SUPPLEMENTARY COUNTER AFFIDAVIT ON BEHALF OF RESPONDENT NO.6

Subject: Appraisal of DPR for "I&D and STP scheme for Gaya town in Bihar" for consideration under Namami Gange – reg.

Observations on Draft DPRFor"PREPARATION OF DETAILED PROJECT REPORT OF GAYA INTERCEPTION AND DIVERSION AND STP SCHEME UNDER NAMMIGANGE IN BIHAR, INDIA"

**REPORT OF SITE VISIT AND DISCUSSIONS WITH BUIDCO ON DRAFT DPR
FOR INTERCEPTION & DIVERSION AND STP SCHEME OF
GAYA, BIHAR DURING NOV 4-5, 2025**

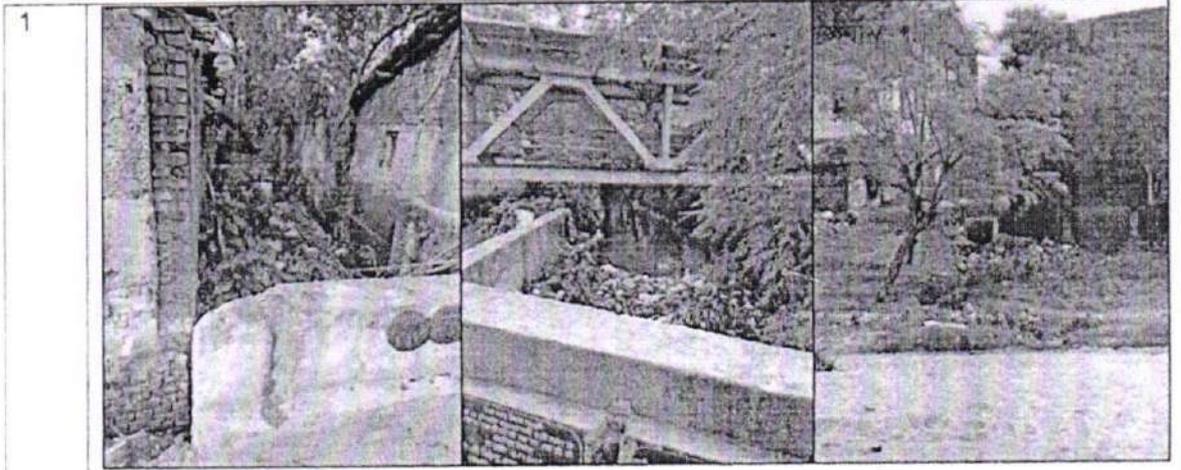
A visit to Gaya city was undertaken during November 4-5, 2025, by Prof. Ashok Kumar Gupta from the Civil Engineering Department, IIT Kharagpur, for discussions on the present status, proposals under review, and visits to the locations of open drains carrying sewage, drain outfalls into the Phalgu River, and the sites of proposed STPs. Discussions were held with the team of engineers/project directors from the Bihar Urban Infrastructure Development Corporation Ltd. (BUIDCO).

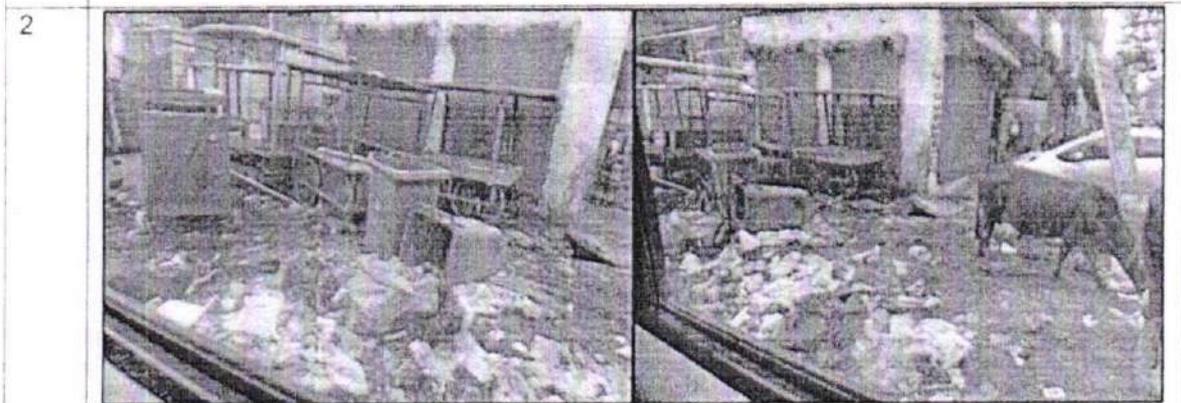
The open drains carrying sewage were observed to have reduced discharge capacities because of sediment deposition and solid waste accumulation. They showed improper slope and hydraulic gradient that resulted in stagnant conditions along several stretches. The locations showed clear evidence of waste disposal into the drains, further obstructing flow and contributing to localized pollution. The unlined sections indicate a high potential for seepage into the surrounding soil, which may lead to contamination of shallow groundwater. In addition, exposure to atmospheric conditions makes these drains susceptible to evaporation losses.

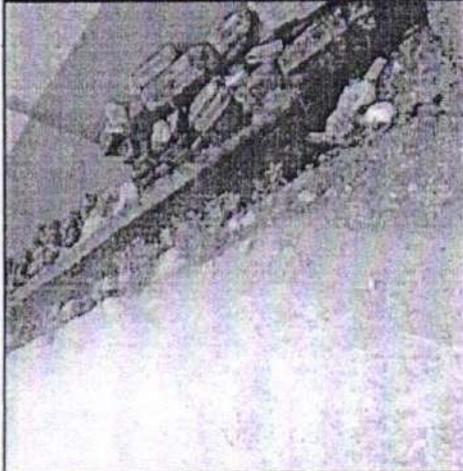
The drains are overgrown with dense vegetation, restricting flow and access. There is no adequate side space available for proper cleaning or maintenance operations. Clearing of vegetation is essential to restore drainage efficiency.
